Meeting Agenda Planning Commission

Wednesday, September 16, 2020

**TECHNICAL REVIEW PLAT REQUIREMENTS
REGULAR PLANNING COMMISSION MEETING
SEPTEMBER 16, 2020**

Plat of
London Towne Subdivision
Unit 2

Plat of
London Towne Subdivision
Unit 3

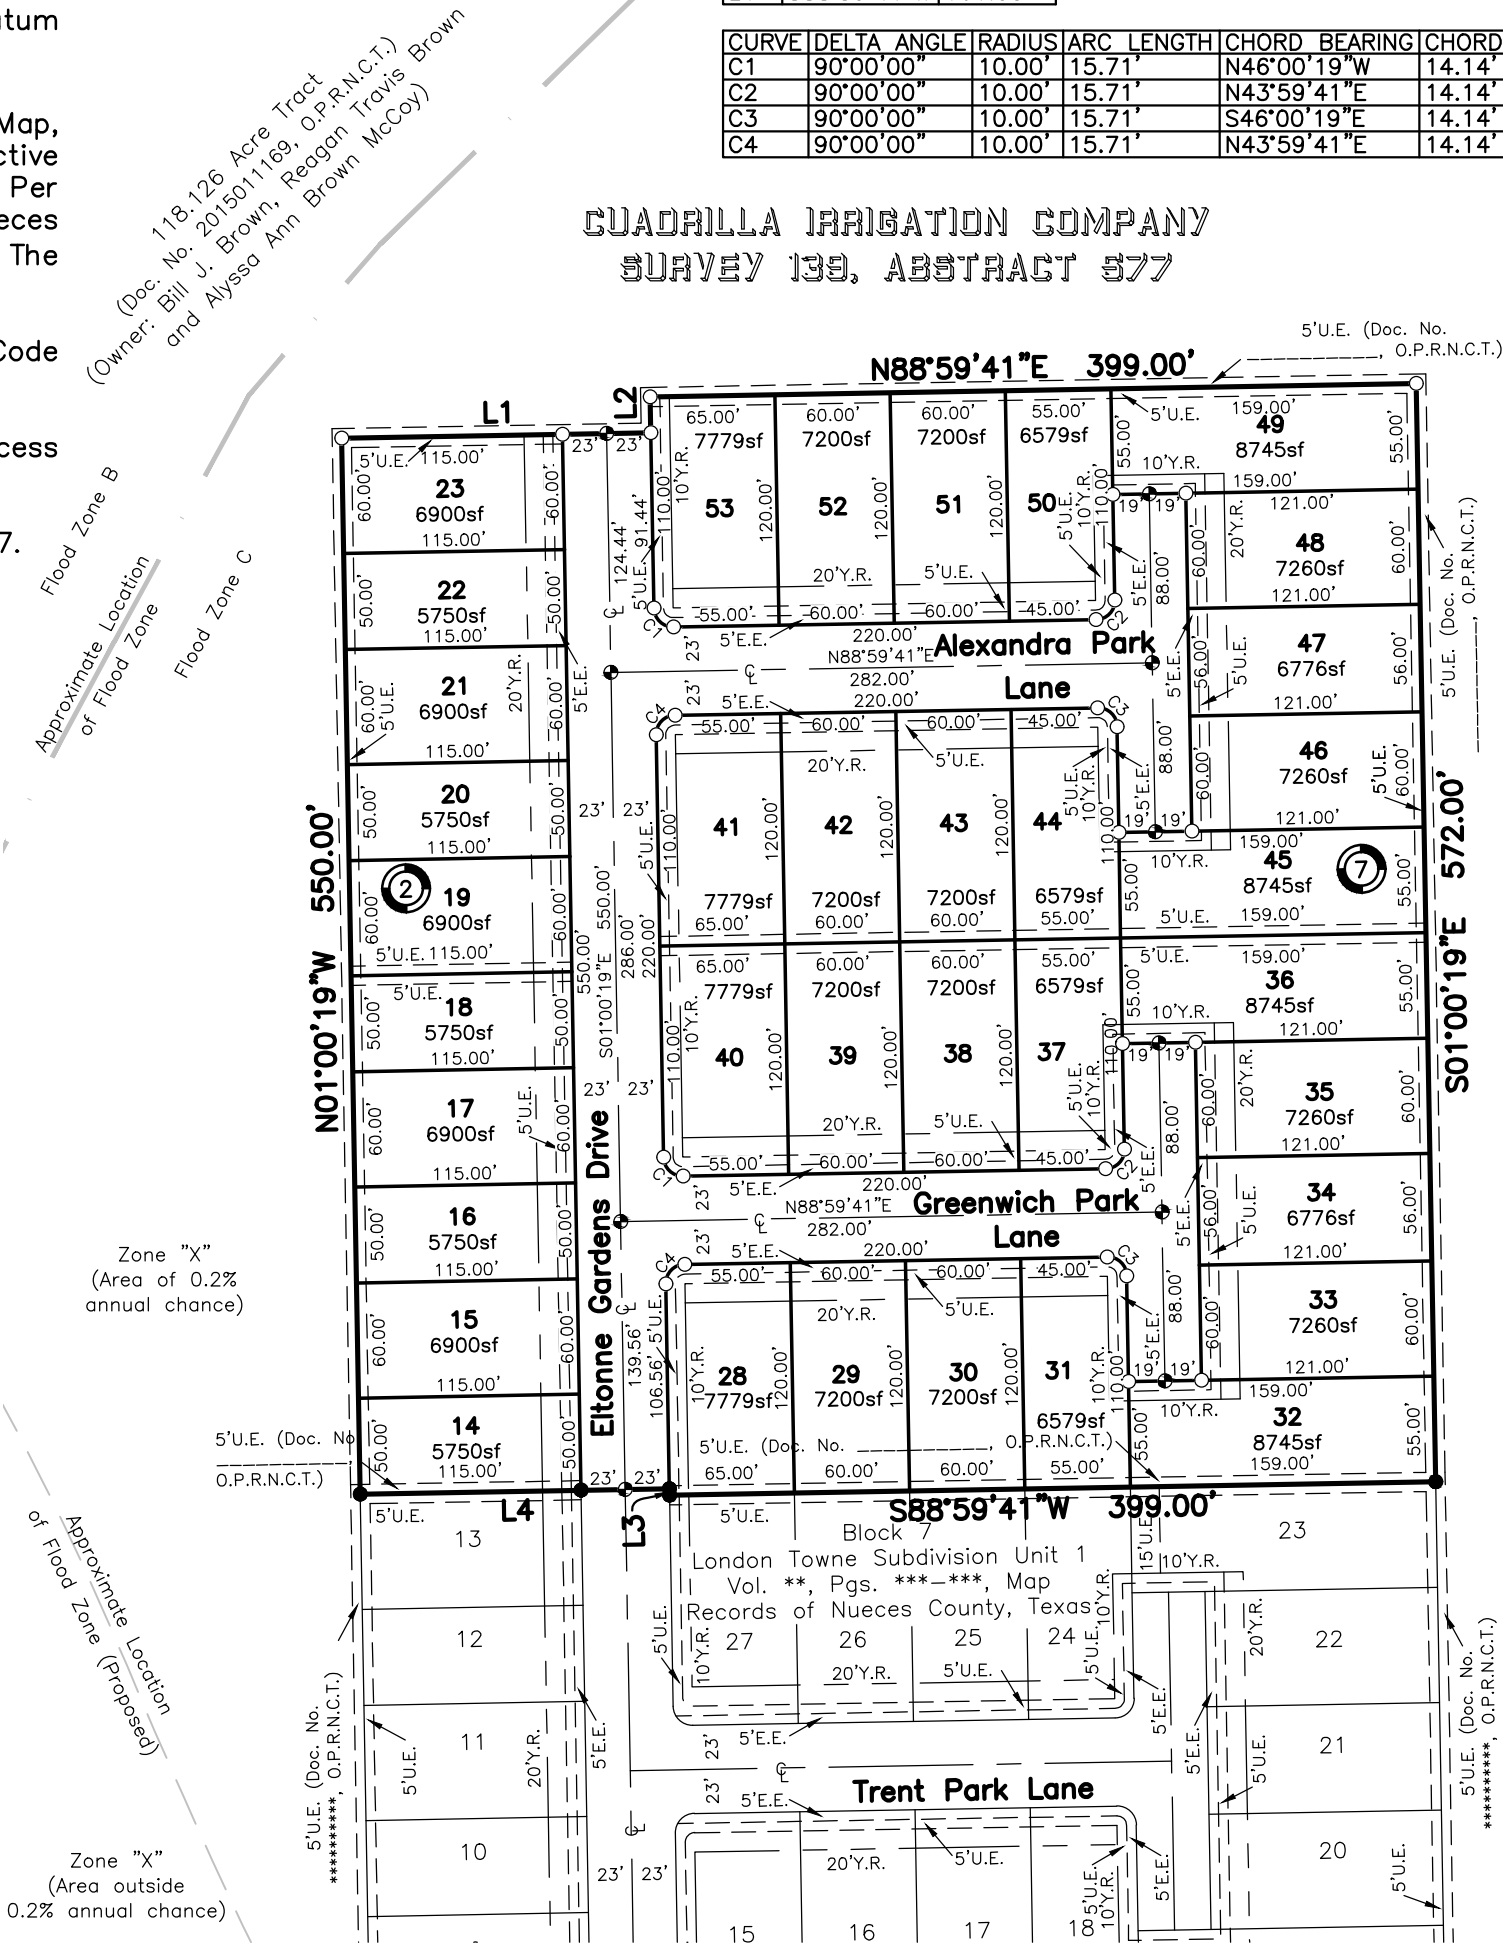
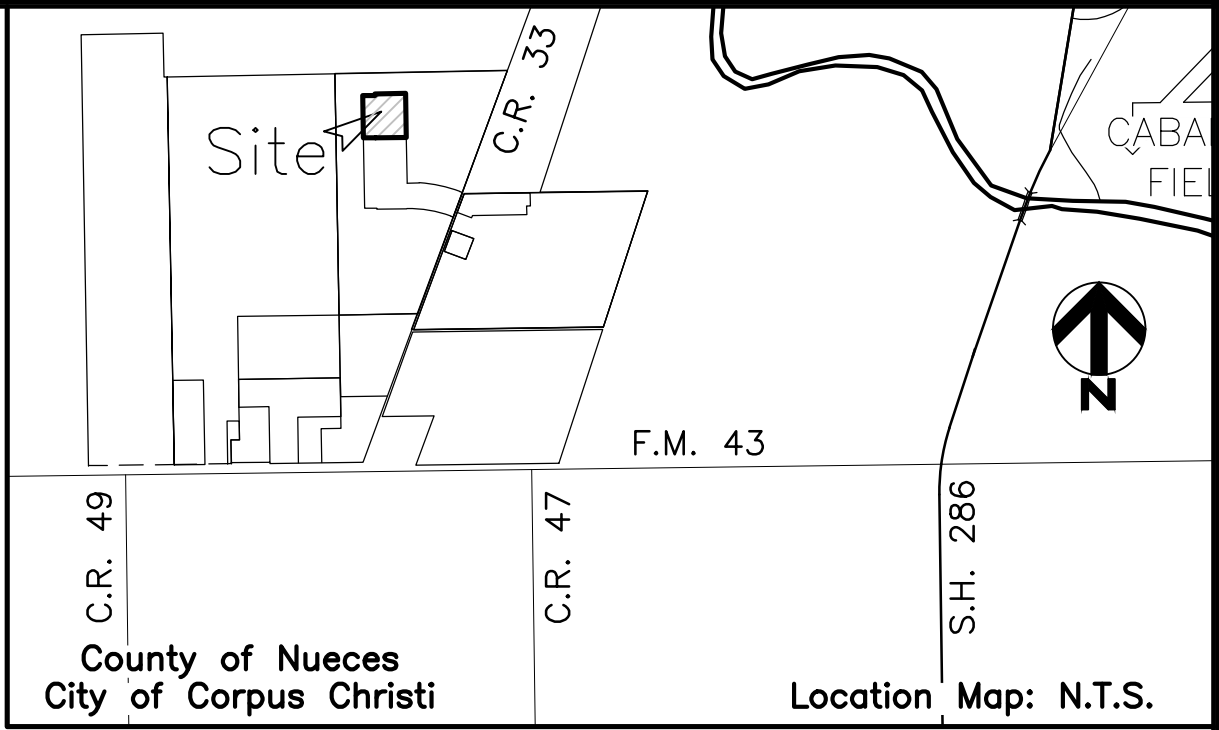
LAND DEVELOPMENT						
No.	Sheet	Comment	Applicant Response	Staff Resolution	Applicant Response	Staff Resolution
1	Plat	Prior to plat recordation London Towne Subdivison Unit 1 will need to be recorded.	Understood	Prior to recordation		
2	Plat	Add the following “Yard Requirement” standard note to the plat: “The yard requirement, as depicted, is a requirement of the Unified Development Code and is subject to change as the zoning may change.”	Note has been added	Addressed		
3	Plat	Identify the dashlines along the inside rear of Block 2, Lots 14-23.	label has been added	Addressed		
4	Plat	Identify the south and north dashlines for Block 2, Lot 23.	label has been added	Addressed		
5	Plat	Identify the dashlines along the abutting rear of Block 7, Lots 49-53.	labels have been added	Addressed		
6	Plat	Prior to recordation, show the document number for <u>any</u> utility easements, temporary right-of-way easements and drainage easements dedicated by separate instrument.	Understood	Prior to recordation

5	Plat	Add the following note "No driveways are allowed on Eltonne Gardens Drive except for Block 2 lots".	Note has been added	Addressed

3	Plat	Solid Waste does not support the "Hammerhead" cul-de-sac design.	Understood to be informational. no design was submitted as this is platting stage. Design to be reviewed and approved with public improvement plans. Hammerheads to conform to current UDC which requires compliance with IFC.	Addressed		
---	------	-----------------------------------------------------------------------------	--------------------------------------------------------------------------------------------------------------------------------------------------------------------------------------------------------------------------------	-----------	--	--

GAS						
No.	Sheet	Comment	Applicant Response	Staff Resolution	Applicant Response	Staff Resolution
1	Plat	Request 10' U.E. between lot 18 &19, blk. 2 5' each side	Easement has been added	Addressed

Plat of
London Towne Subdivision
Unit 5

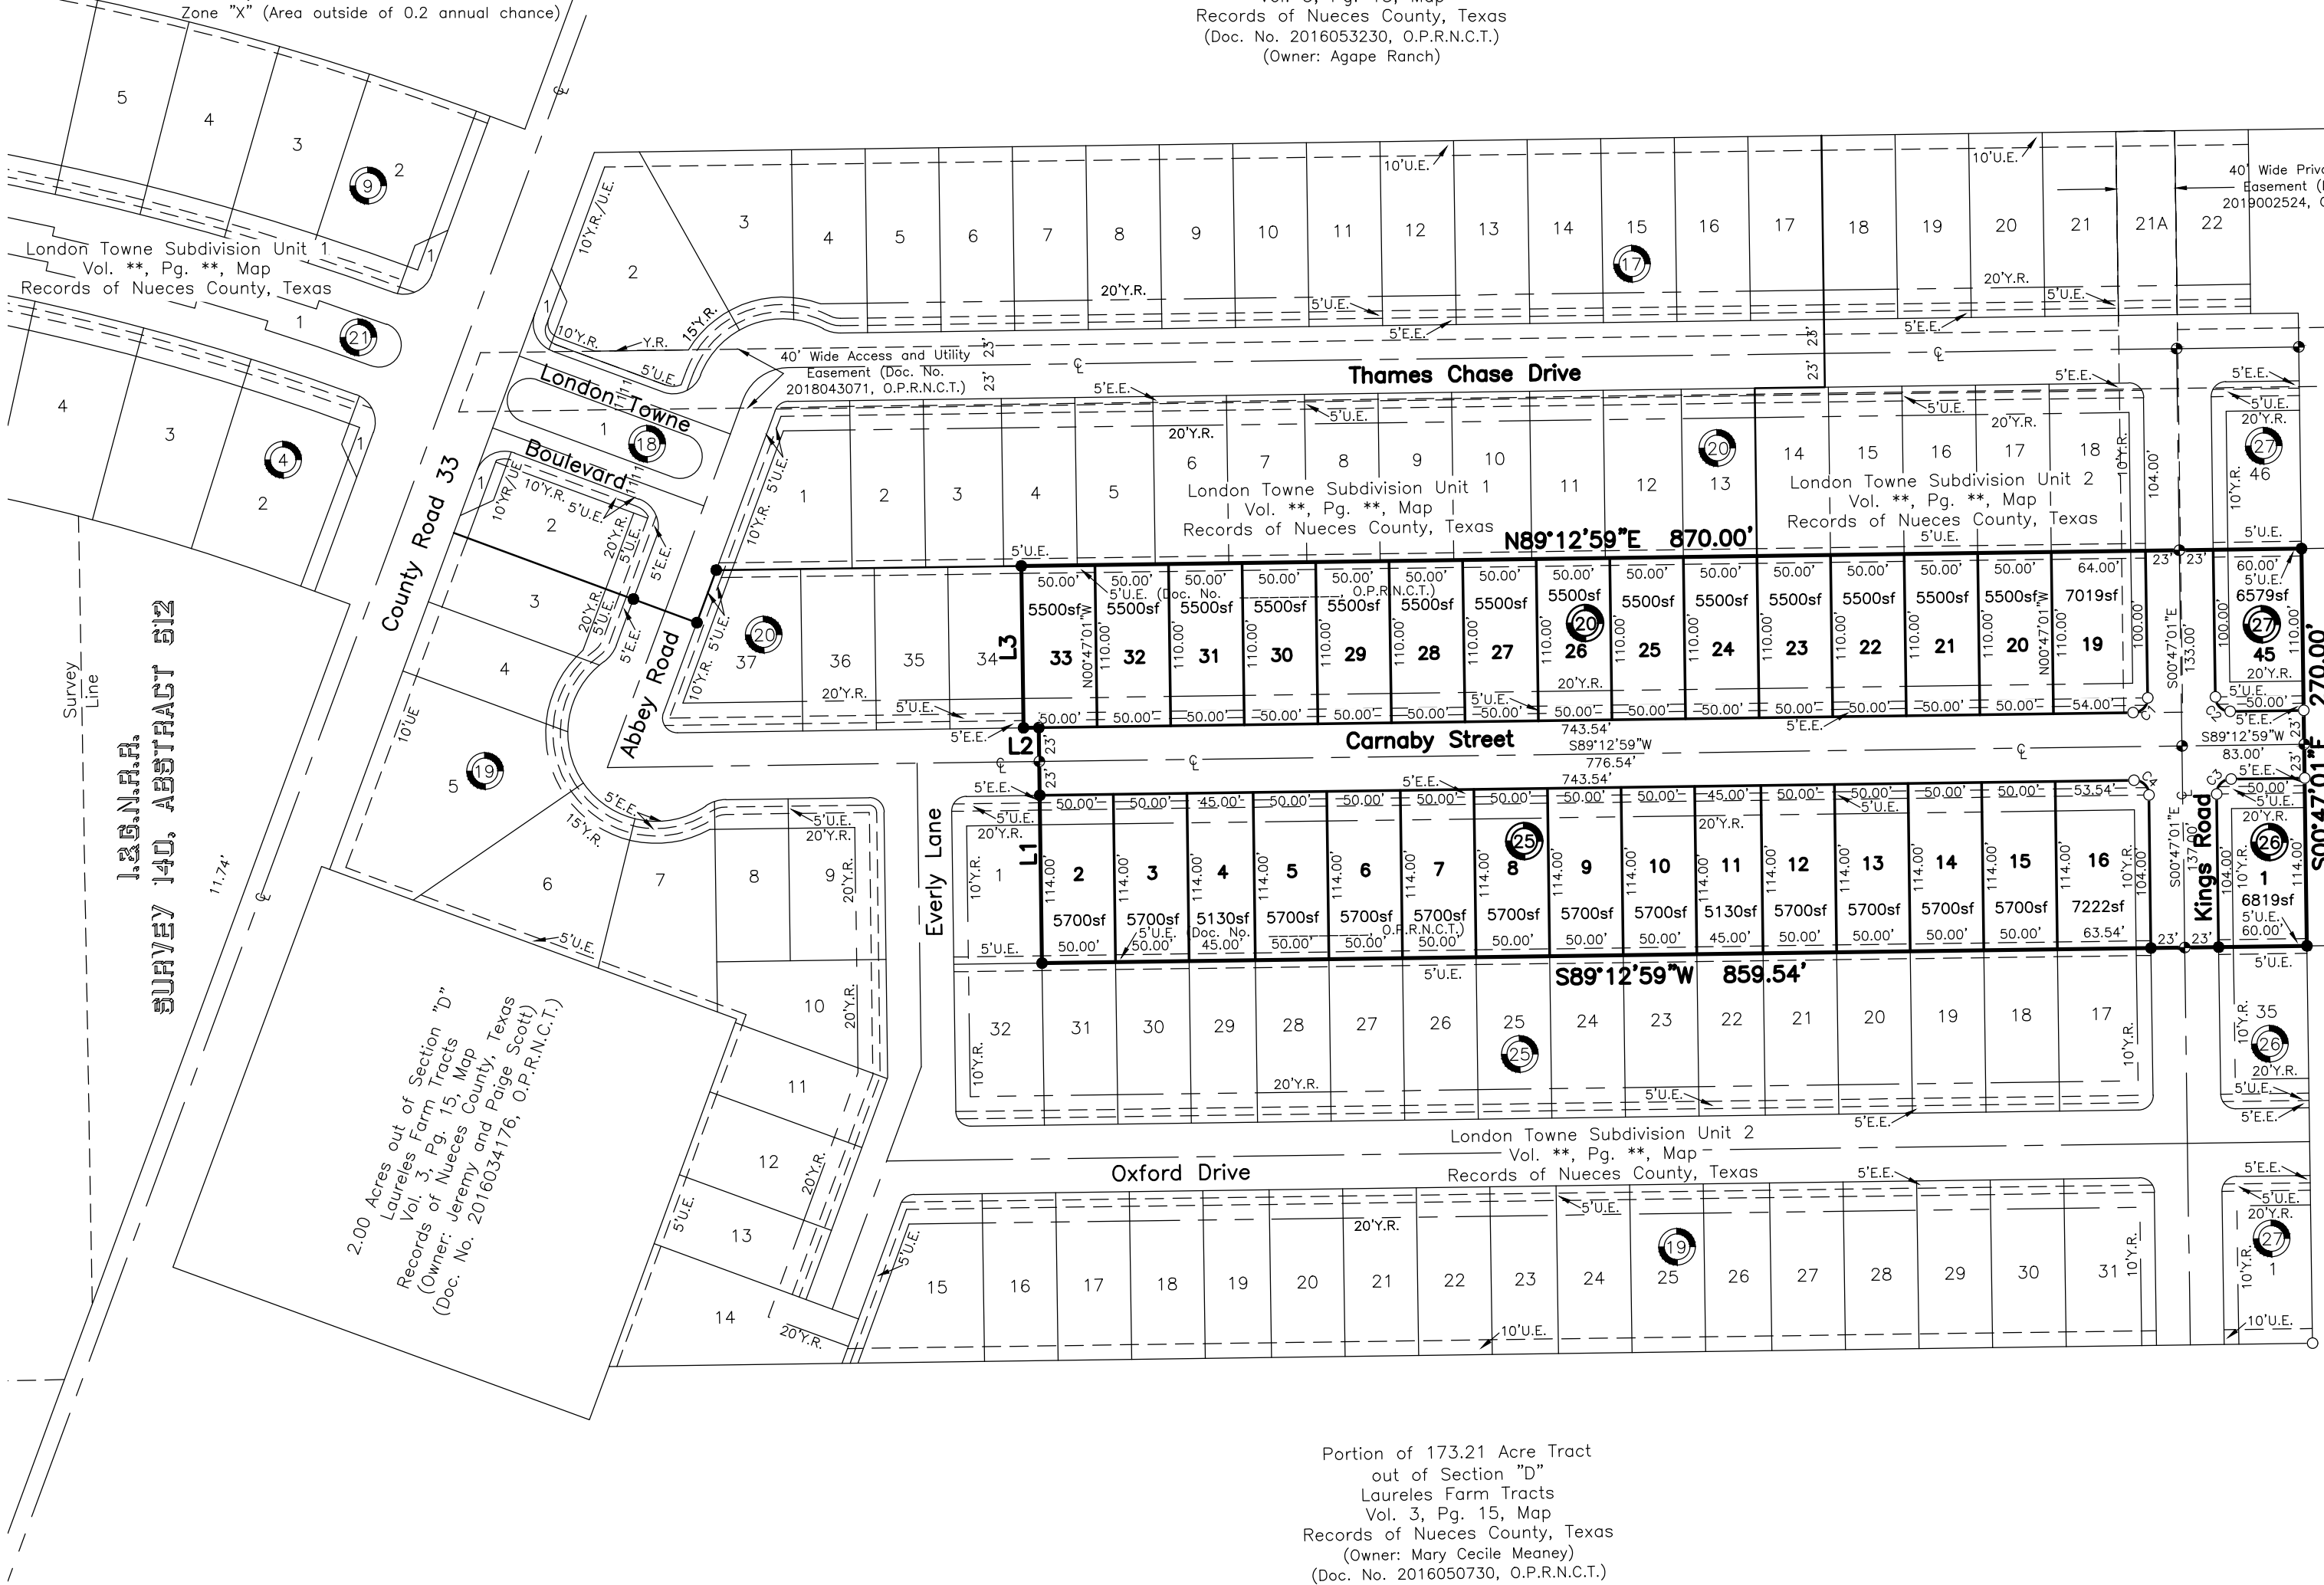
4	Plat	D103.1 Access road width with a hydrant. Where a fire hydrant is located on a fire apparatus access road, the minimum road width shall be 26 feet (7925 mm), exclusive of shoulders	Noted			
5	Plat	Note: Street width for Fire Access C.R. 33 is substandard and affects emergency services response. Portions of C.R. 33 have not yet been widened to the required dimensions to support fire department response.	Noted			
6	Plat	D102.1 Access and loading. Facilities, buildings or portions of buildings hereafter constructed shall be accessible to fire department apparatus by way of an approved fire apparatus access road with an asphalt, concrete or other approved driving surface capable of supporting the imposed load of fire apparatus weighing at least 75,000 pounds (34 050 kg).	Noted			
7	Plat	503.2.3 Surface. Fire apparatus access roads shall be designed and maintained to support the imposed loads of fire apparatus and shall be surfaced so as to provide all weather driving capabilities	Noted
